Metro Knitting & Dyeing Mills Ltd (Factory-02) (Extension 2)

Charabag, Ashulia, Savar
(23.885180N, 90.310123E)
29 February 2024

Observation-1: Lack of Design documents. Building-5 (Extension Building).

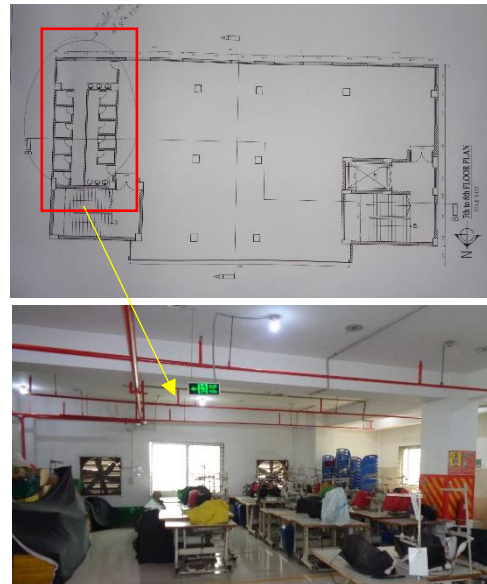
During the inspection, as-built architectural and structural drawings, load plans, geotechnical investigation report, and material test reports were available for the structure. However, a full set of design documents was unavailable per BNBC.

Staircase and OHWT

The toilet is not constructed as per the drawing.

The structural details of the Overhead Water Tank and stair top details are not provided in the structural drawing. Also, a mismatch was found in the as-built drawing. In the floor layout plan, the toilet has been shown but at site condition, the toilet has not been constructed.

Description: As per BNBC, every building or structure designed shall have its design documents prepared following the provision of Section 1.9.1. The design document shall include a design report, and a set of structural drawings, which shall be prepared in compliance with section 1.9.1.1 and section 1.9.1.2 as per BNBC.

The factory engineer is required to prepare the full design documents based on in-situ material strength and load plan including a design report based on the FEA model in compliance with section 1.9.1 (part 6, BNBC).
